Access Compliance Report

Public Rights-of-Way

(Curb Ramps)

Intersection ID: N/A	Main Street: PAMPLIN_CT	Cross Street: N/A	Location: SE
ADA ID: C4F83ADFCB64	Ramp Type: Perp	Initial Pass/Fail: Fail	Overall Compliance: No
Codes/Mitigation Info/Possible Solution		Field Measurements/Component Compliance	
Severity Score: 33.75

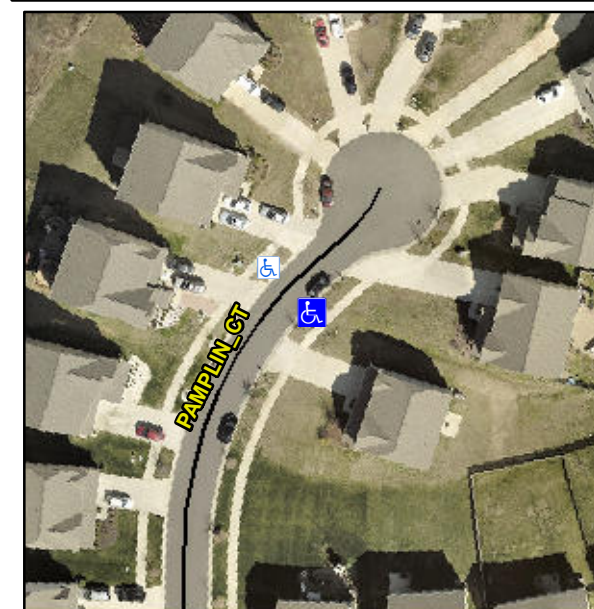
Not Found, R304.5.1, R304.2.2

Compliance	Description	Data	Compliance	Description	Data
N/A	Ramp Length (in)	93.0	No	Ramp Slope (%)	13.6
No	Ramp Width (in)	46.5	Yes	Ramp XSlope (%)	1.1
N/A	Flare Type LT	N/A	N/A	Flare Type RT	N/A
N/A	Flare Slope LT (%)	N/A	N/A	Flare Slope RT (%)	N/A
N/A	Flare Traversable LT?	N/A	N/A	Flare Traversable RT?	N/A
N/A	Landing Length (in)	N/A	N/A	DWS Provided?	N/A
N/A	Landing Width (in)	N/A	N/A	DWS Contrast?	N/A
N/A	Landing Slope (%)	N/A	N/A	DWS Length (in)	N/A
N/A	Landing X Slope (%)	N/A	N/A	DWS Full Width?	N/A
N/A	Landing Curb? (Y/N)	N/A	N/A	DWS Offset (in)	N/A
N/A	Shared Landing?	N/A			
N/A	Gutter Ponding?	N/A	N/A	Gutter Slope (%)	N/A
N/A	Gutter Lip Ht (in)	N/A	N/A	Gutter X Slope (%)	N/A
N/A	Painted X Walk1?	No	N/A	Painted X Walk2?	N/A
	X Walk 1 Direction	To NW		X Walk 2 Direction	N/A
N/A	X Walk 1 Width (in)	N/A	N/A	X Walk 2 Width (in)	N/A
	X Walk 1 Slope (%)	2.8		X Walk 2 Slope (%)	N/A
	X Walk 1 X Slope (%)	1.4		X Walk 2 X Slope (%)	N/A

Remove & Replace Entire Ramp.
